## 14\_15 Guardrail on Curb and Gutter Berm

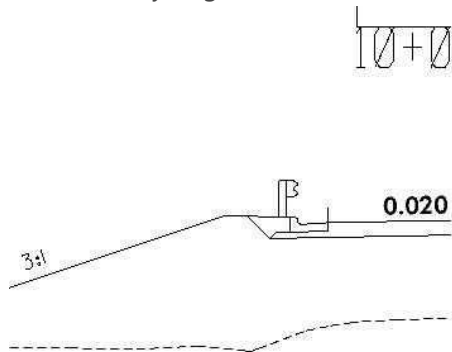
1. How does the "CS01 WIDEN BY GUARDRAIL LINE" Criteria variable work for curb and gutter typical sections with berms?
2. Why does Criteria place the guardrail up in the air freestanding sometimes?

2. The formula used to locate the point where the guardrail is to be drawn, WHEN the guardrail line is at the face of the curb, is wrong (going in the opposite direction and slope) and the berm width distance added an extra 6" that is not needed. Remember that the berm width is always measured from the face of curb and not the back of the curb. This is where I think the extra 6" for the curb width came from. This is what you get with the old formula for CSLP01.CRI.

This is what you get with the modified formula for CSLP01.CRI.

In summary, berm width AND the offset distance of the guardrail line in the DSN are not considered when the guardrail line is NOT at the face of the curb. Berm width is only considered when the guardrail line is at the face of the curb.
